DART AEROSPACE LTD		Work Order:	81324
Description: Crosstube Assembly (205/212/412 High Fwd)		Part Number:	D212-664-141
Inspection Dwg: D212-664-141 Rev: D		Page 1 of 1

DRAWING NO. D212-664-141	TITLE XTUBE ASSY (205/212/412 HI FWD)	REV. D	DART AEROSPACE LTD ENGINEERING ORDER		D.E.O. NO. D212-664-141-D-1	SHEET NO. SHEET 1 OF 2	SCALE NTS
DRAWN	CHECKED	MFG. APPR.	APPROVED	DE APPR.	DATE	DATE	DATE
11.04.07	11.04.11	11.04.12	11/04/12	11.04.12	11.04.12	11.04.12	11.04.12

PURPOSE:

ADD AN INSPECTION WINDOW TO UNDERSIDE OF CROSSTUBE.

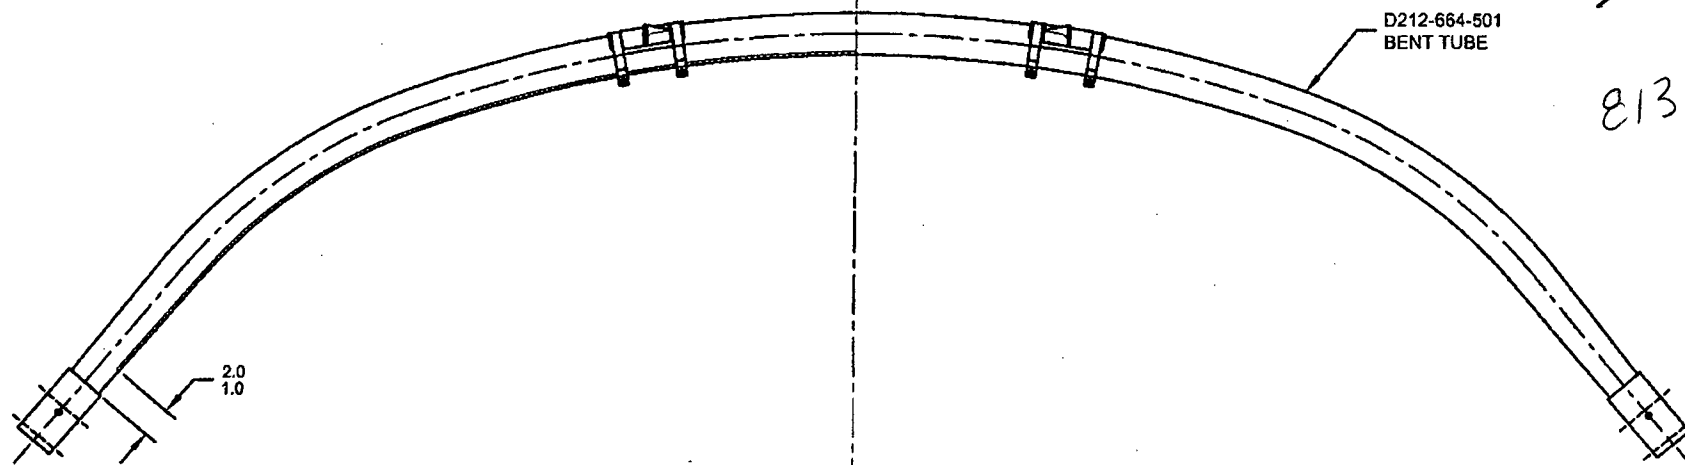
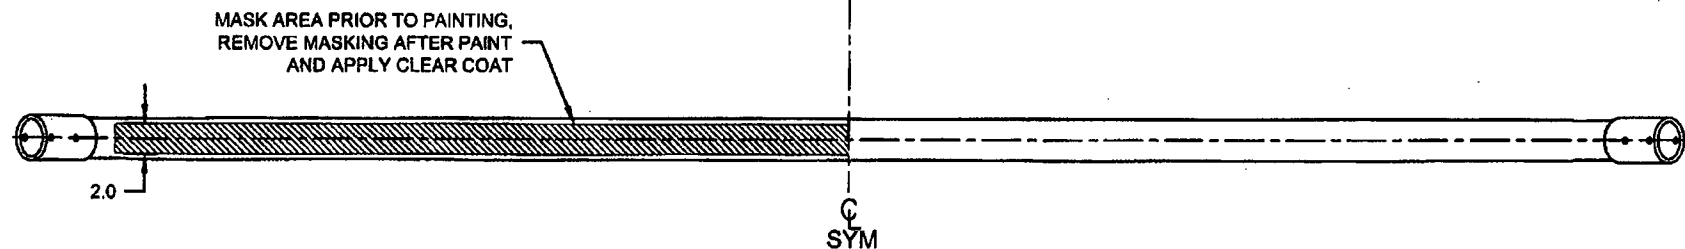
NOTES 2 OF SHEET 1 IS AMENDED AS FOLLOWS:

- 2) FINISH: CHEMICAL CONVERSION COAT PER DART QSI 005 4.1
PRIME INSIDE AND OUTSIDE PER DART QSI 005 4.2
MASK UNDERSIDE OF CROSSTUBE AS SHOWN (HATCHED AREA) AND
PAINT OUTSIDE PER DART QSI 005 4.2
REMOVE MASKING AND APPLY CLEAR COAT
